AGENDA

Town Planning & Building Committee

Tuesday, 3 April 2018 at 6.30pm

This report considers a planning application for the construction of a three level single dwelling on vacant land at No. 73B (Lot 303) Staton Road, East Fremantle.

SITE PLAN, SECTIONS - PLANNING APPROVAL

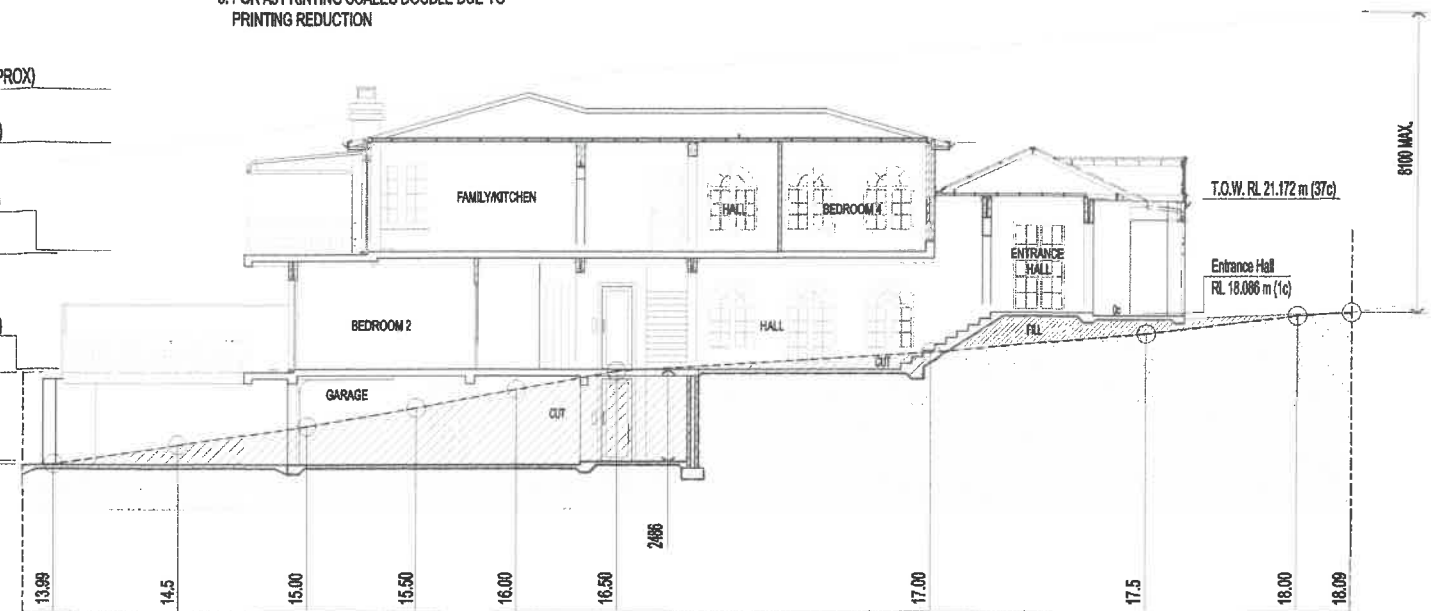
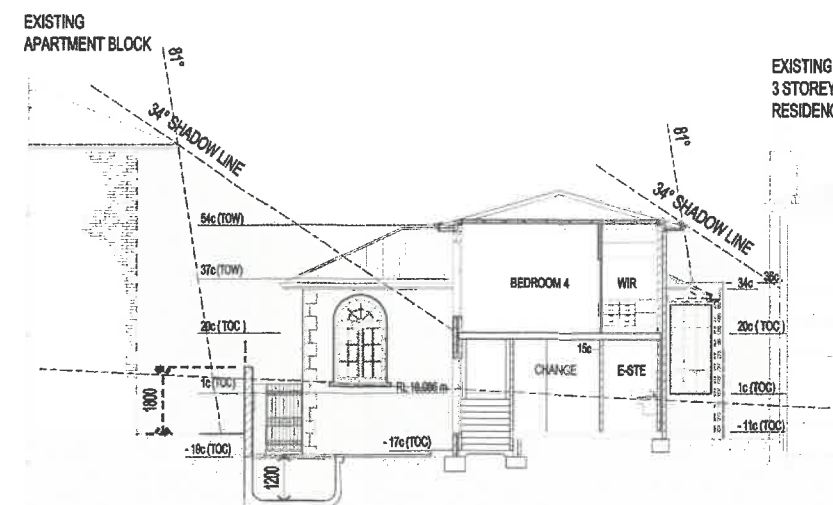
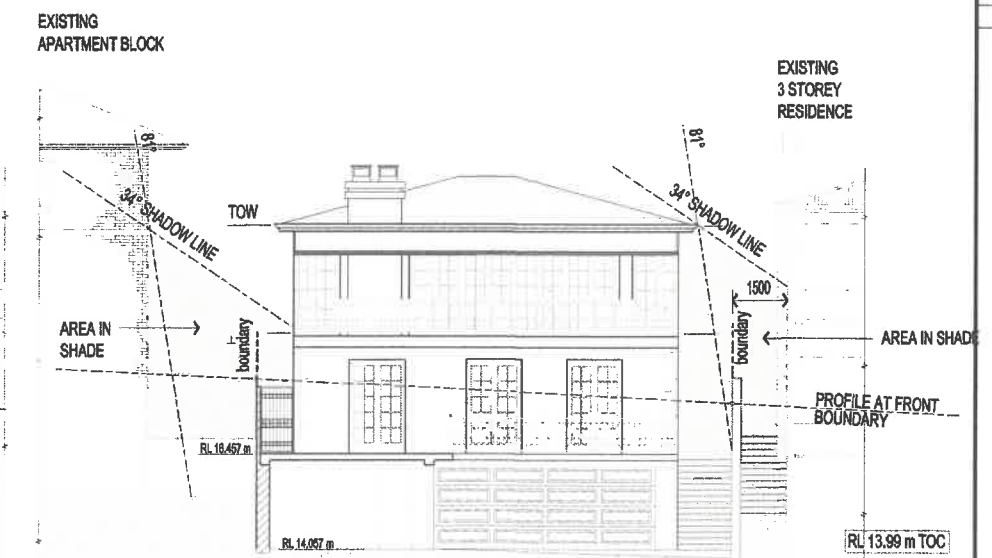
The applicant's response is not considered to address the concerns of the submitter with respect to the nil setback proposed and the overlooking concerns. Conditions are recommended in regard to the setback for bedroom 1 being increased to comply with the R-Codes and the visual privacy screening of the bedroom window to comply with R-Code requirements. This is discussed further in the 'Statutory Assessment' section of the report. It should be noted it may not be necessary for the screening condition to be applied if the window is removed to achieve compliance with the required setback under the R-Codes.

amended set of plans reduced the height from that initially proposed to address the concerns of neighbours regarding views being obstructed. However, as discussed above, the excavation at the rear of the site increases the building height limit and from a western perspective the height is exceeded (i.e. top of wall 9.0 metres and 10.2 metres to top of a pitched roof). Views are not impeded from this perspective. It should be noted that significant excavation at this end of the site has resulted in a lowering of the original ground level so the building remains below the height limit of 8.1 metres from natural ground level.

- (1) The setback of bedroom 1 (southern elevation) is to be no less than 1.0 metre from the southern boundary. The amended setback to be indicated on the plans submitted with the Building Permit application to the satisfaction of the Chief Executive Officer;

- (2) The permanent installation of a fixed privacy screen or screening film on the bedroom 1 window (western elevation) in accordance with 'Deemed to Comply' clause C1.2 of the Residential Design Codes of WA. The detail to be to the satisfaction of the Chief Executive Officer and indicated on the plans submitted with the Building Permit application.

TITLE
ELEVATIONS - PLANNING APPROVAL

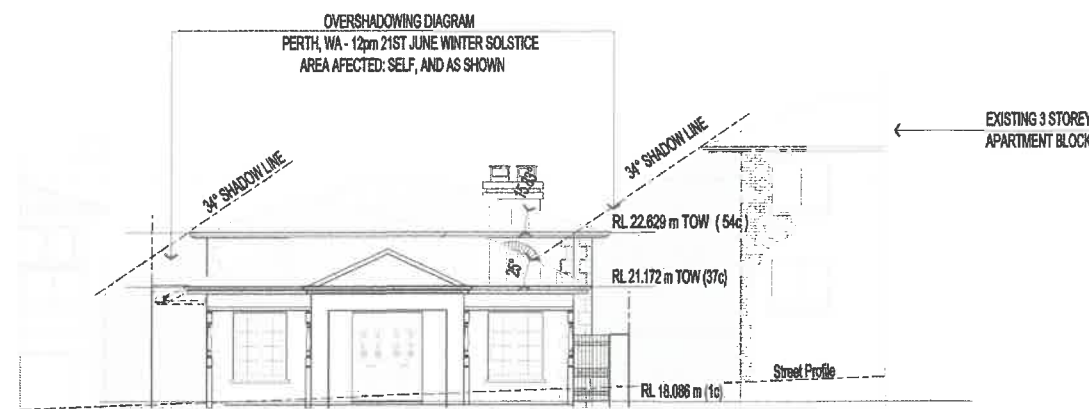
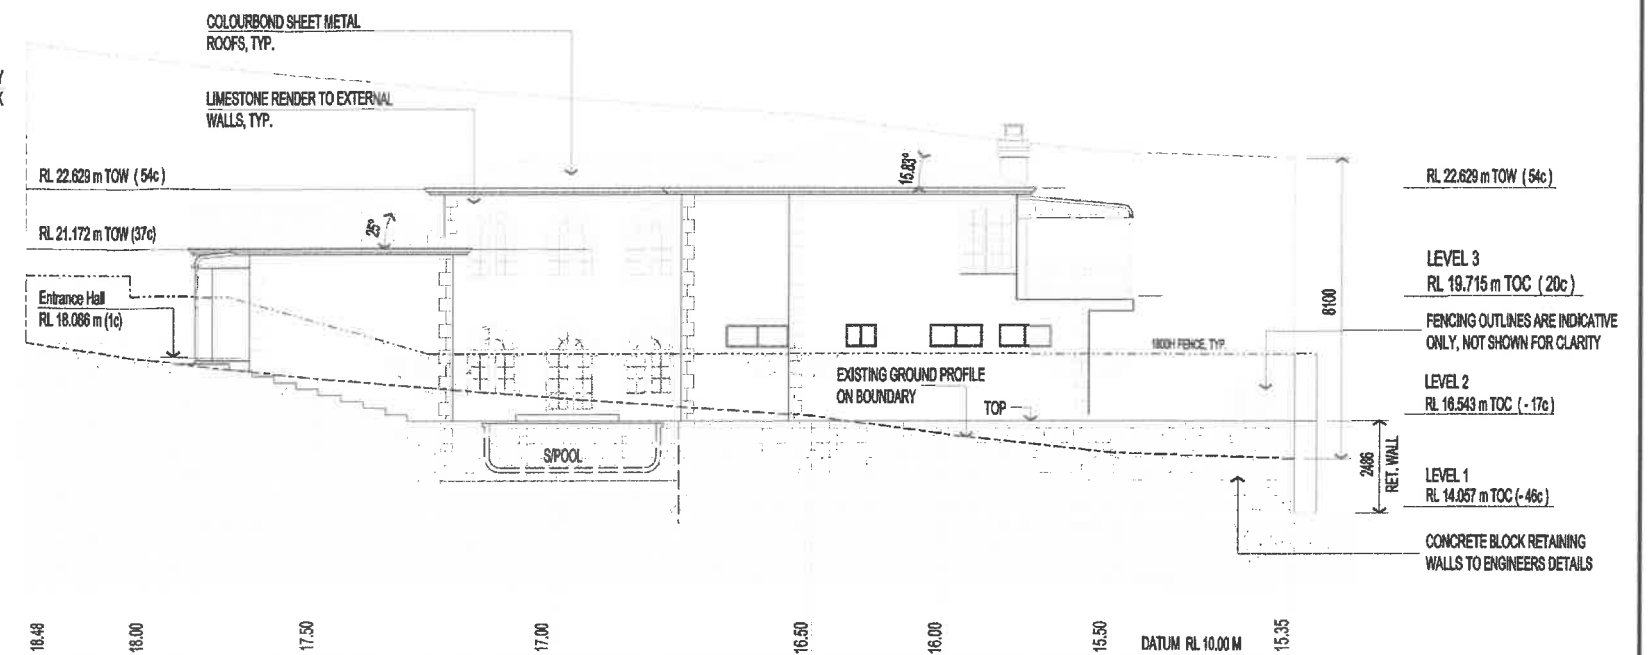
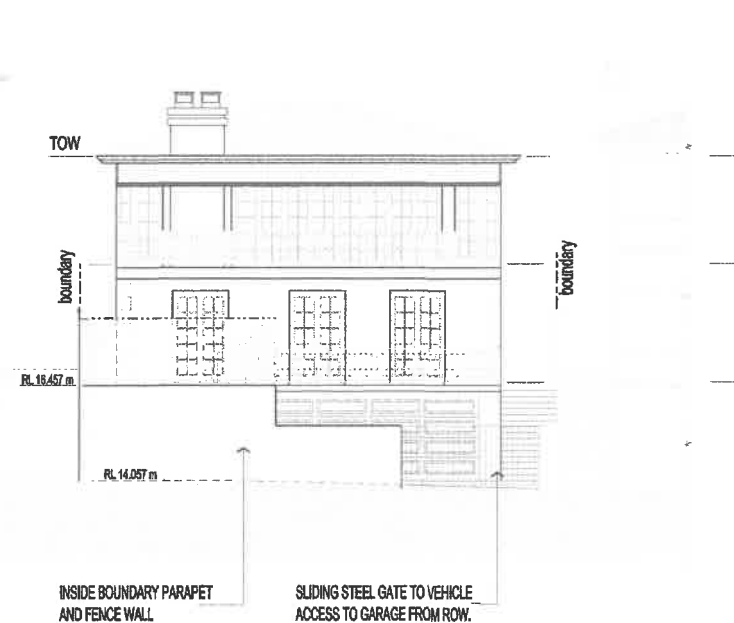
1. *The proposed southern parapet wall for bedroom 1 will have minimal impact on the adjoining southern dwelling. The parapet wall will be built behind the existing limestone boundary wall which will provide visual relief through setback and texture articulation. The parapet wall will largely be*
